CONSTRUCTION PLANS  
FOR  
**THE RIDGE AT LORSON RANCH FILING NO. 1**  
STREET & STORM SEWER CONSTRUCTION PLANS

THE RIDGE AT LORSON RANCH FIL NO. 1  
STREET / STORM SEWER  
CONSTRUCTION PLANS

DATE: NOV, 2021  
PROJECT NO: 100.066  
SHEET NUMBER: C0.1  
TOTAL SHEETS: 49

SHEET NUMBER C6.20

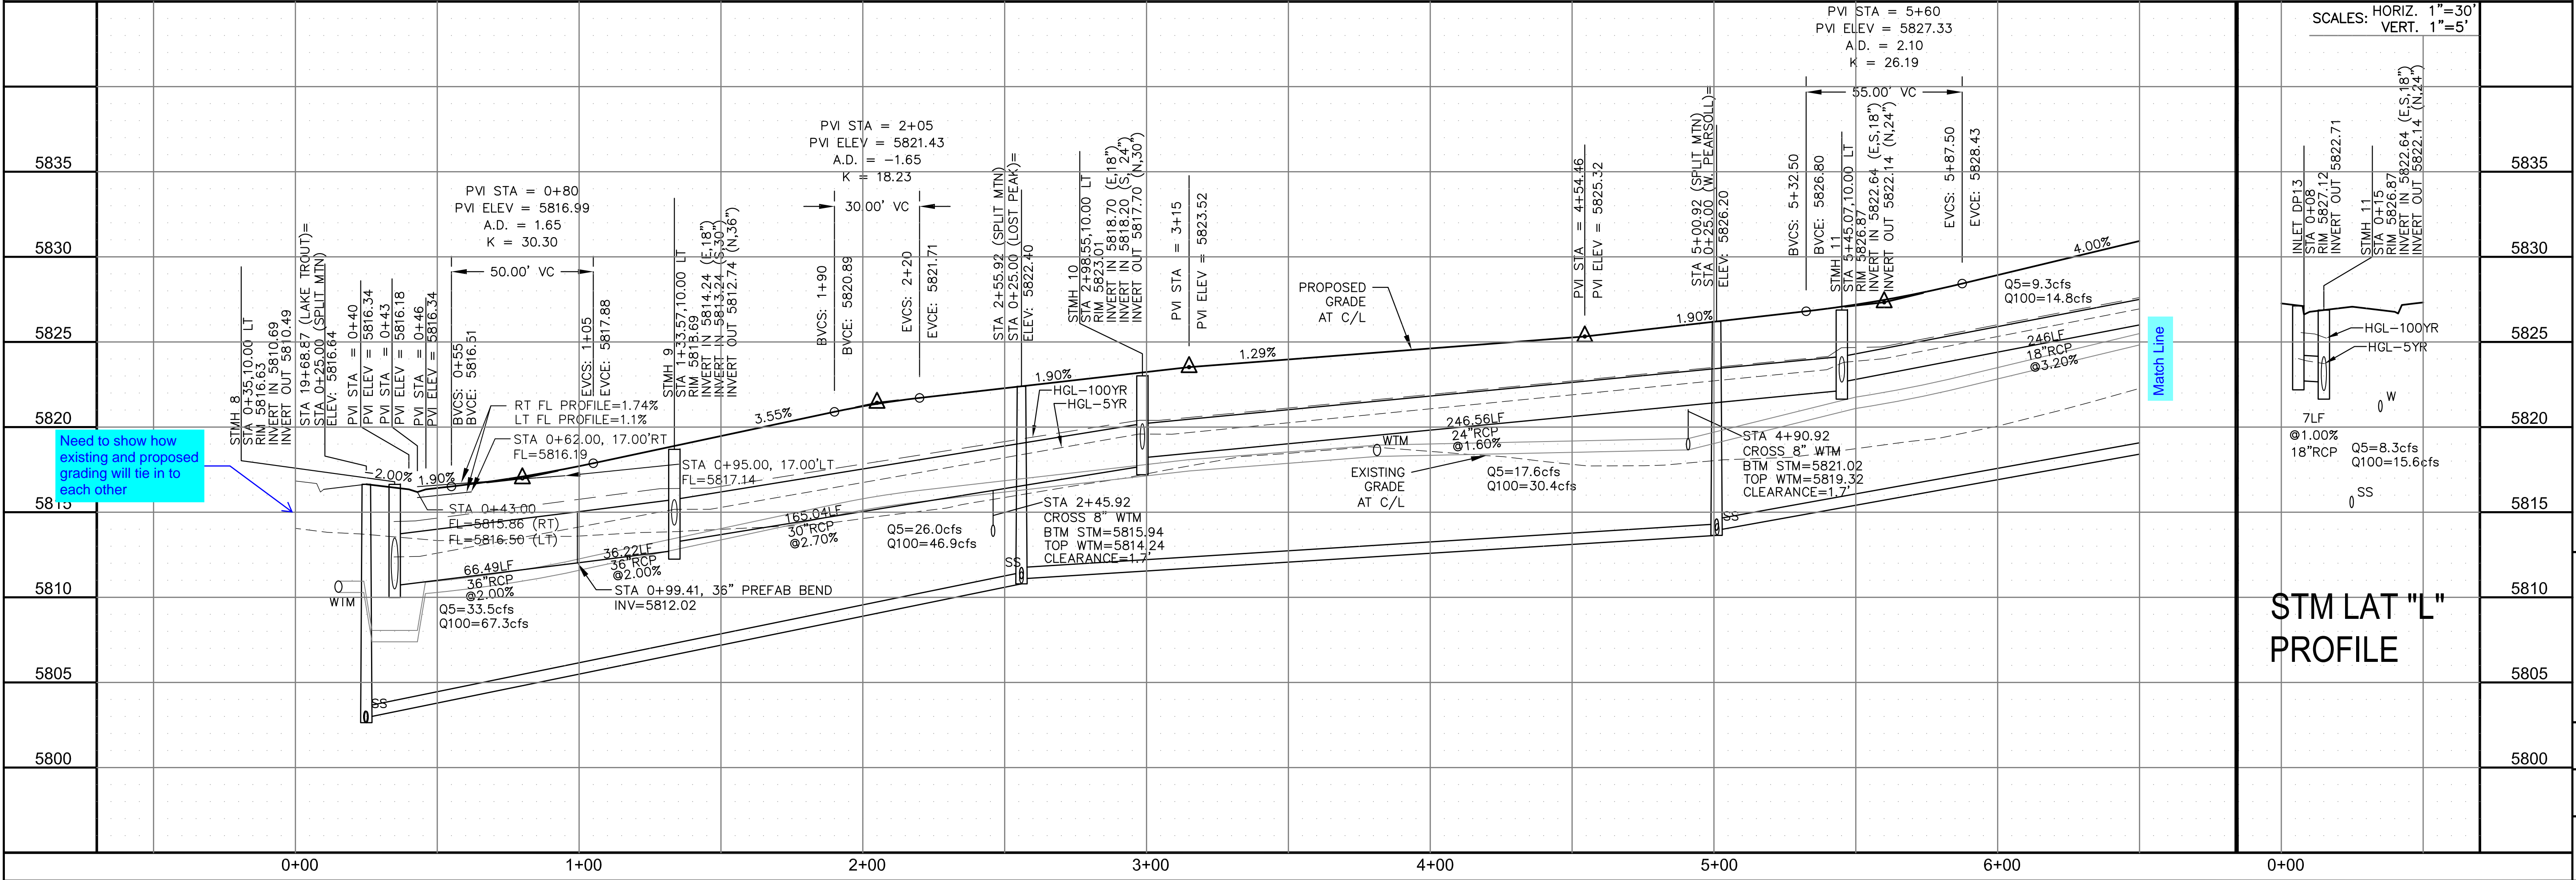
Need to show how existing and proposed grading will tie in to each other

**SPLIT MOUNTAIN DRIVE**

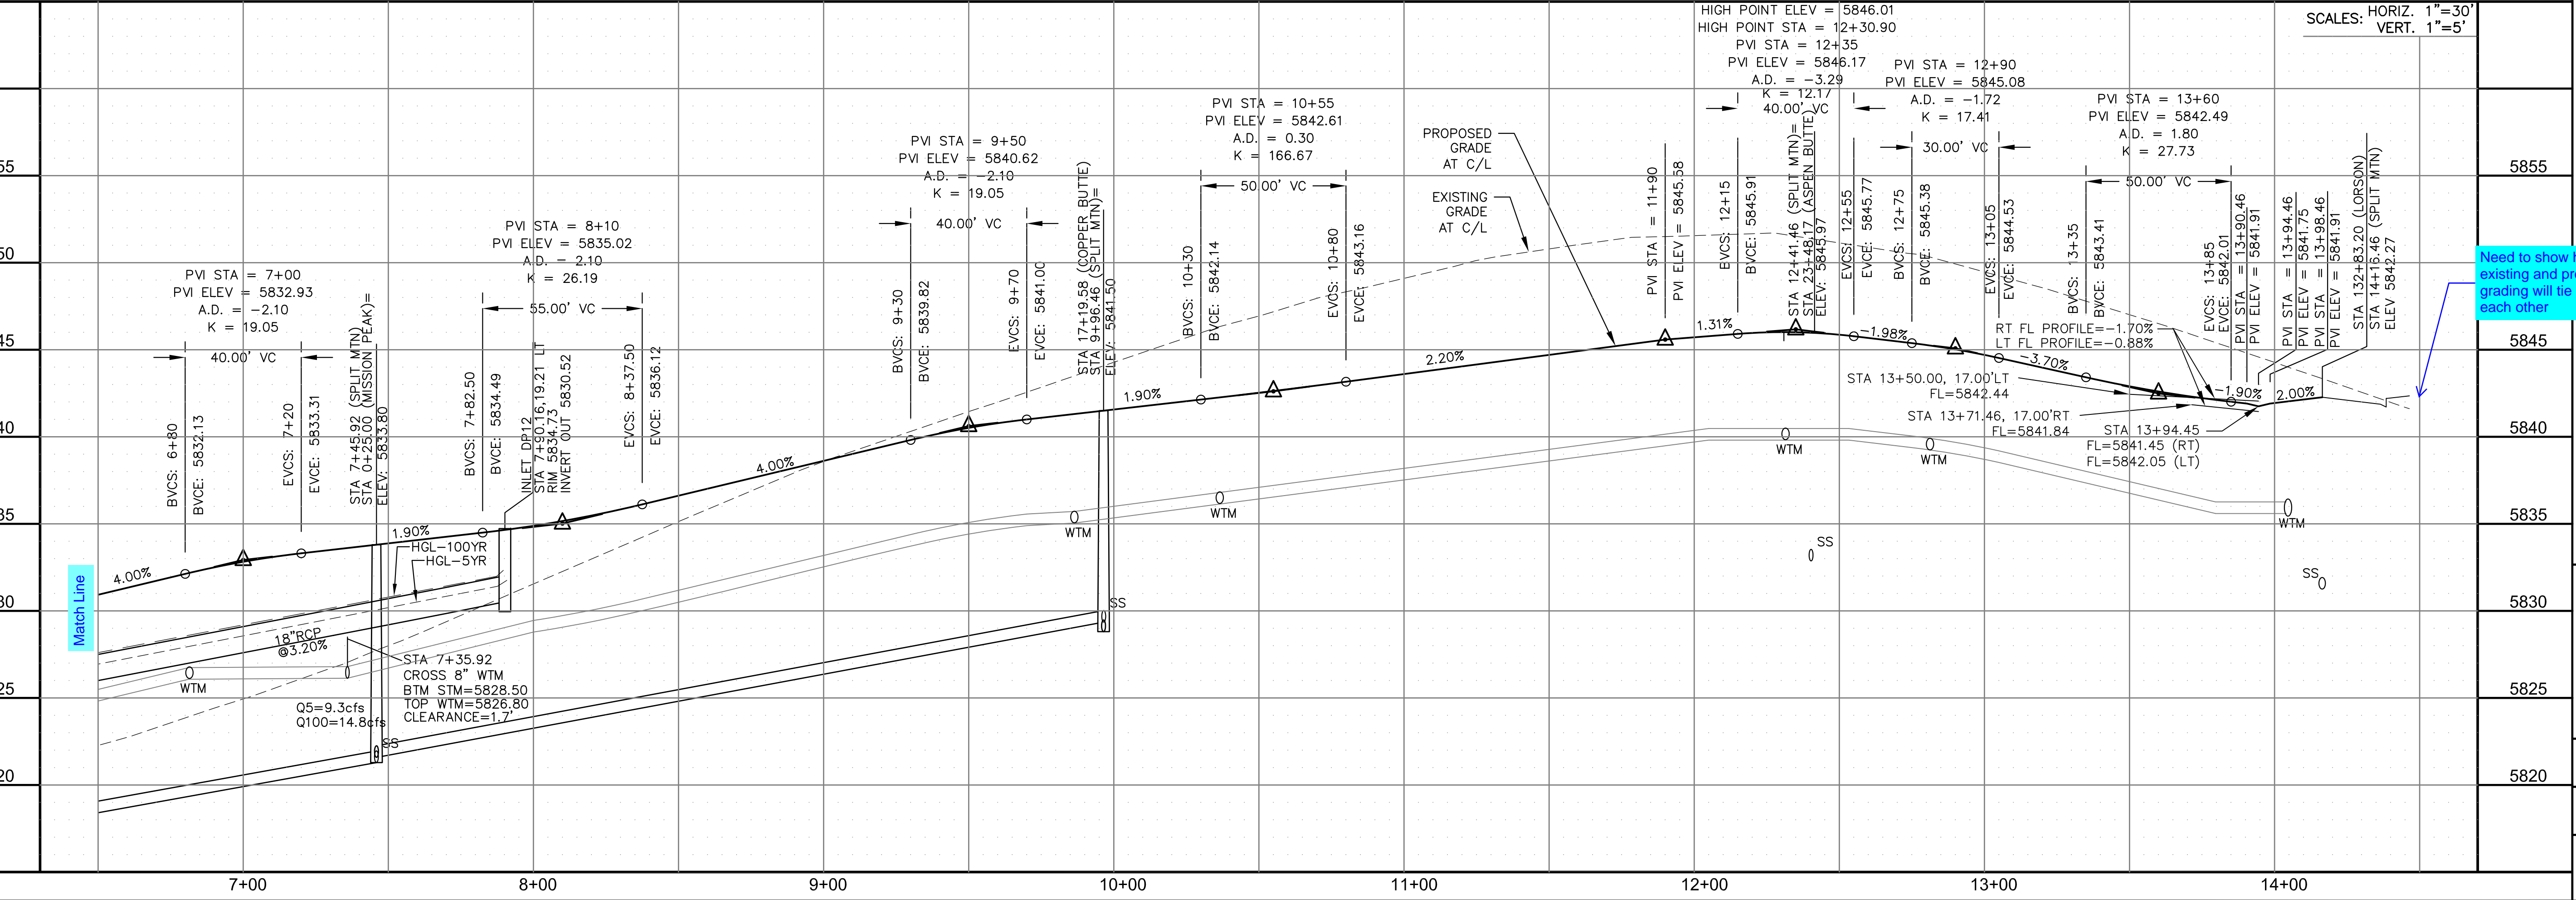
Need to show how existing and proposed grading will tie in to each other

DATE: NOV, 2021  
 PROJECT NO. 100.066  
 SHEET NUMBER C6.25  
 TOTAL SHEETS: 49

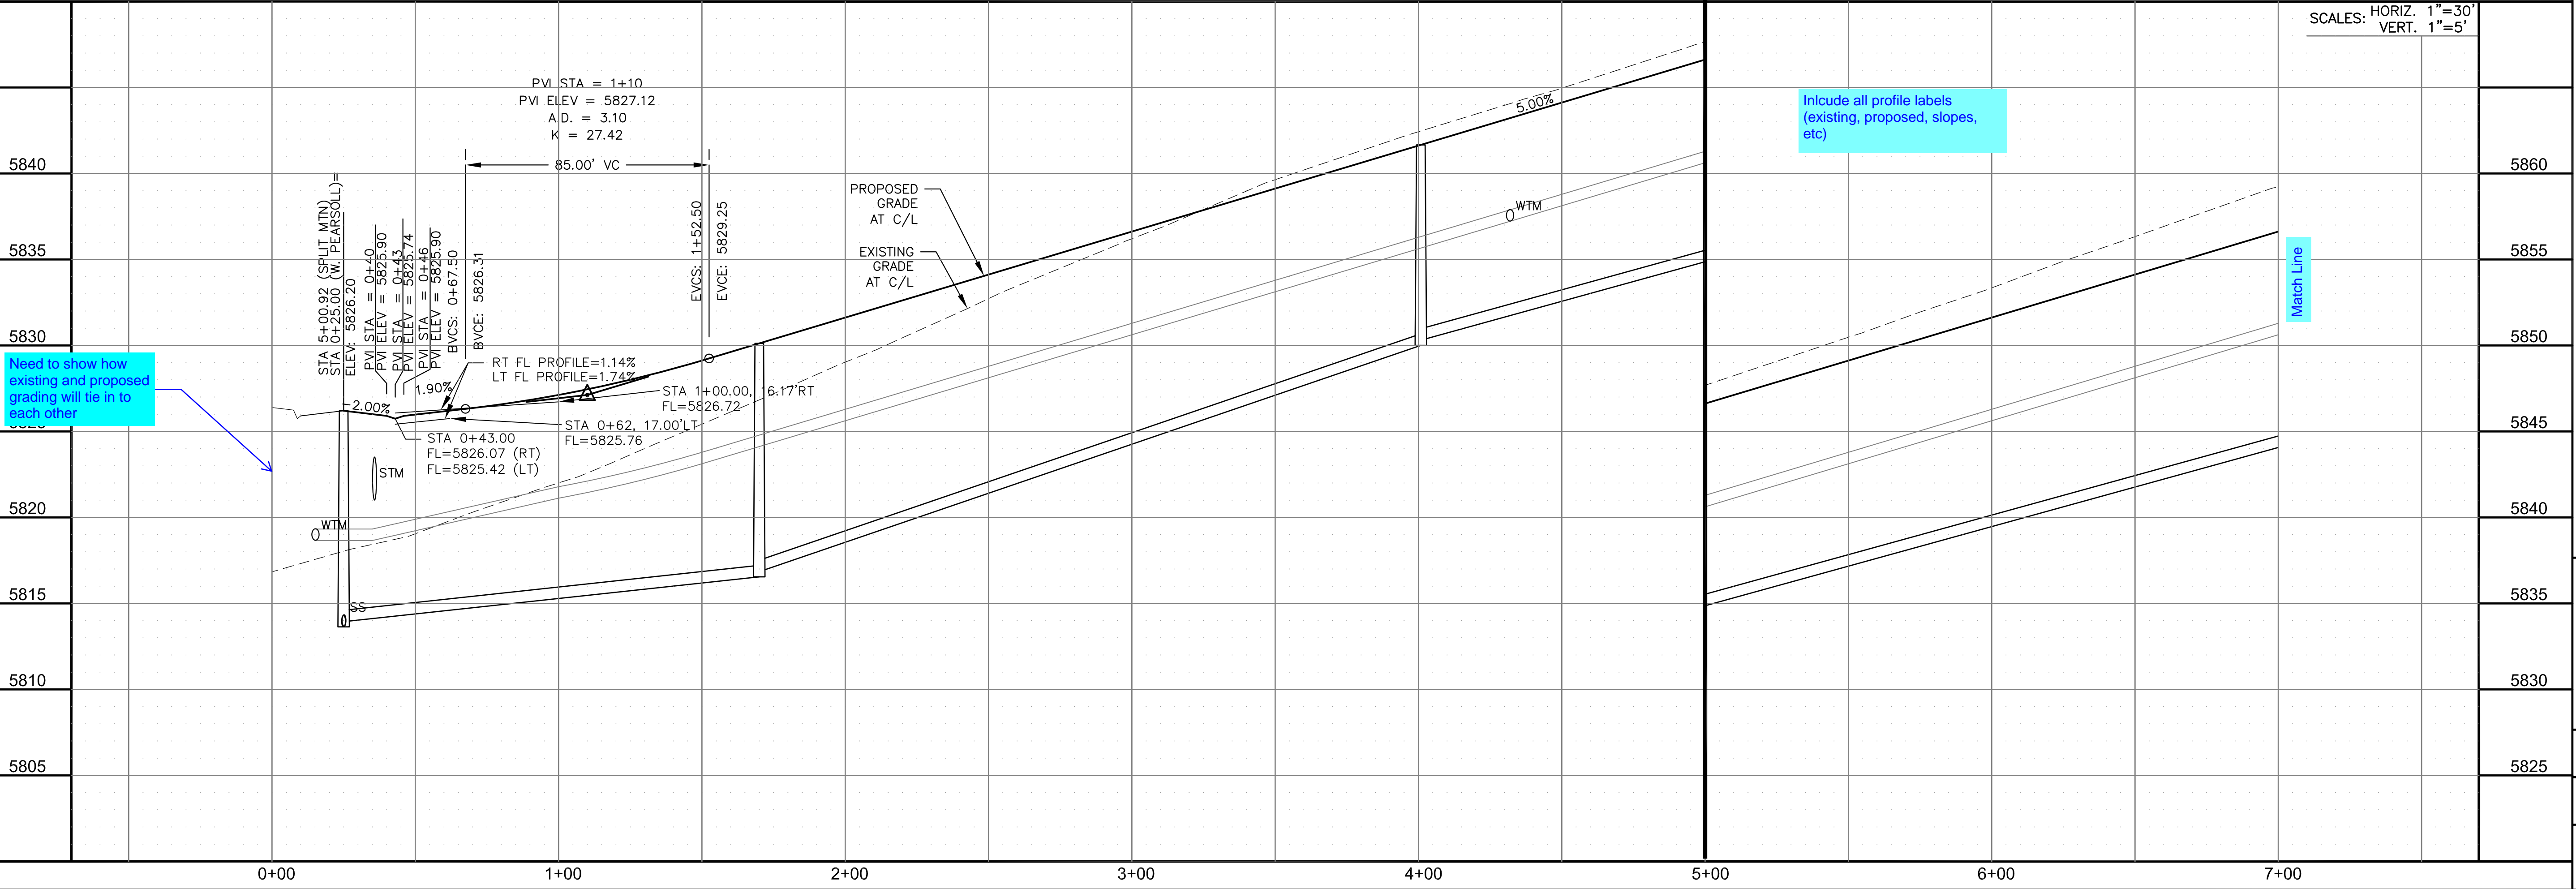
Need to show how existing and proposed grading will tie in to each other

DATE:  
 NOV, 2021  
 PROJECT NO.  
 100.066  
 SHEET NUMBER  
 C6.30  
 TOTAL SHEETS: 49

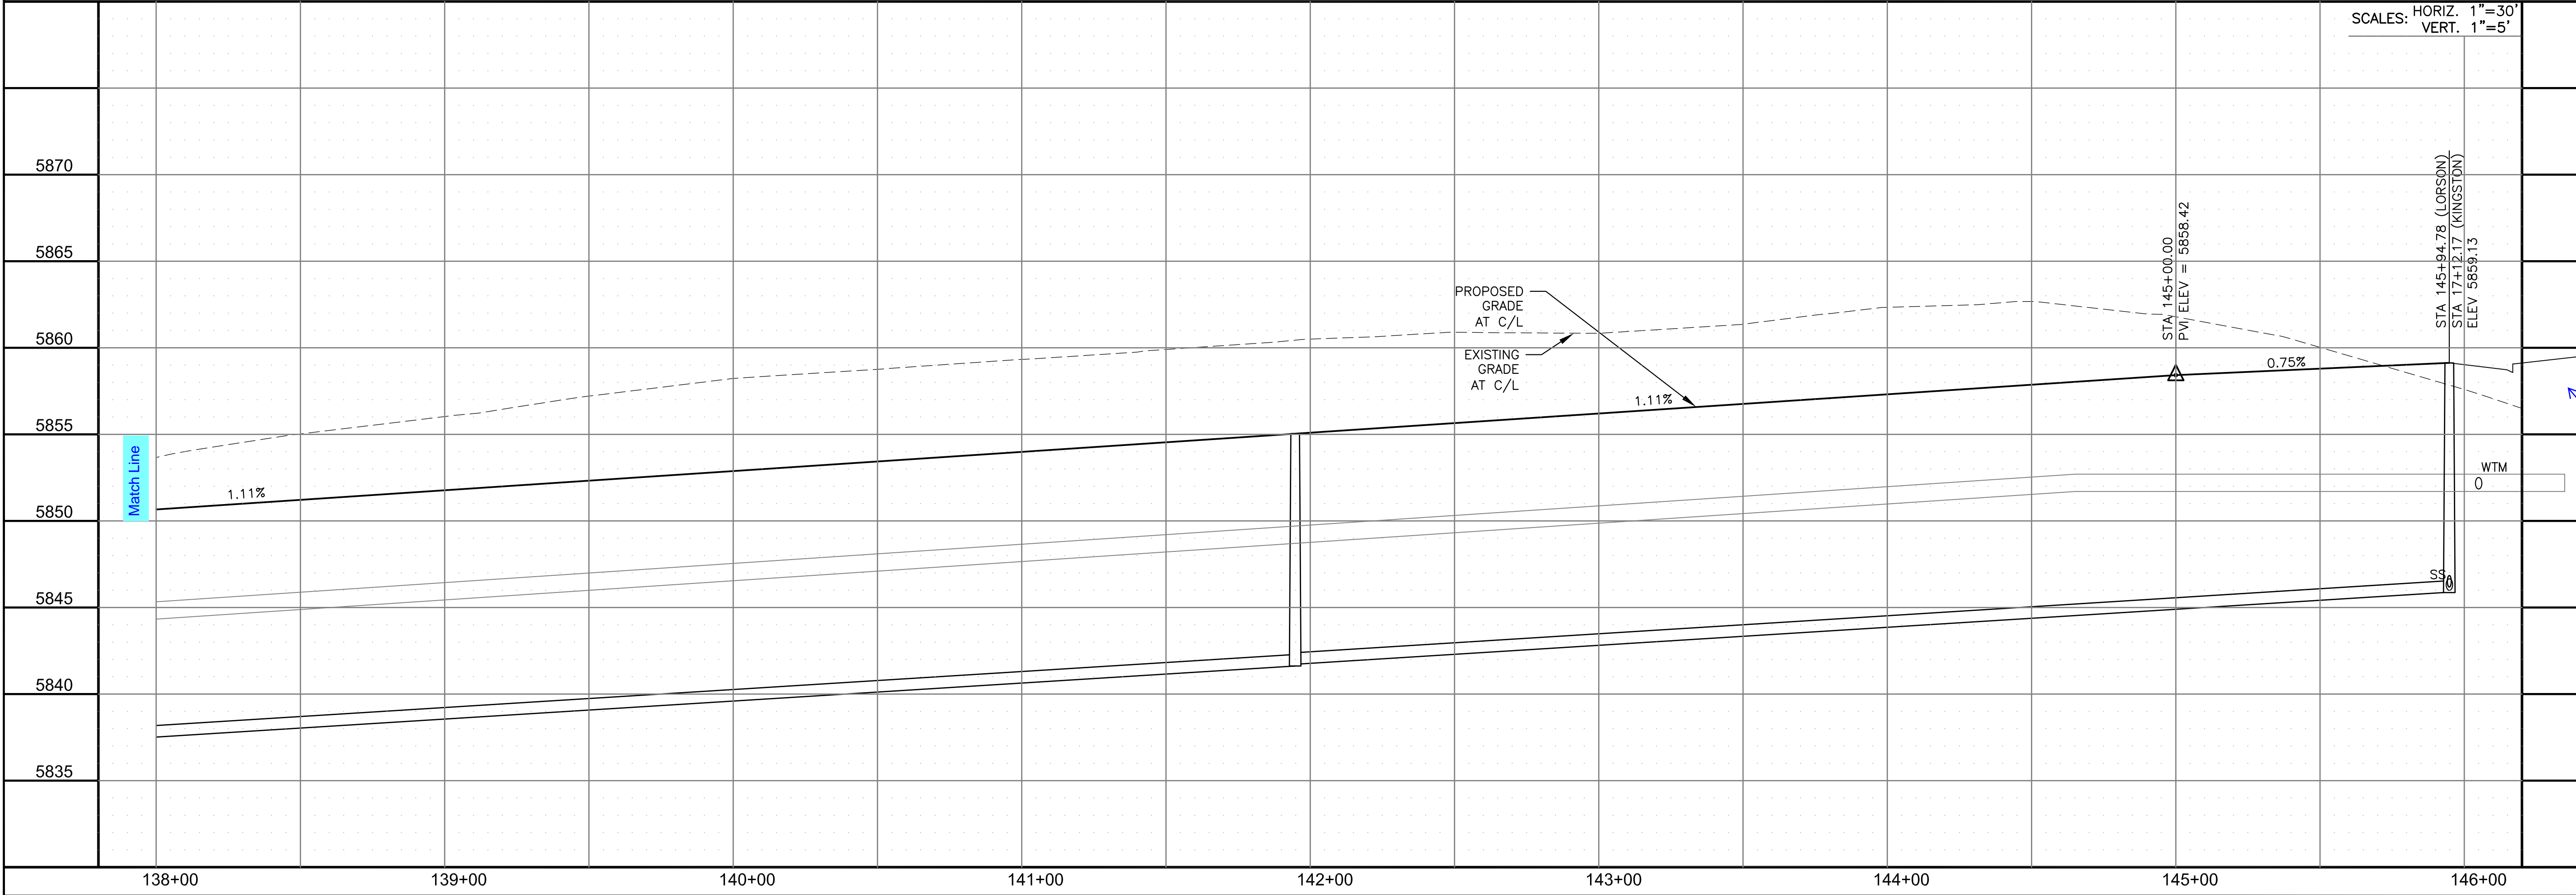
Need to show how existing and proposed grading will tie in to each other

Missing C117, C122 in table
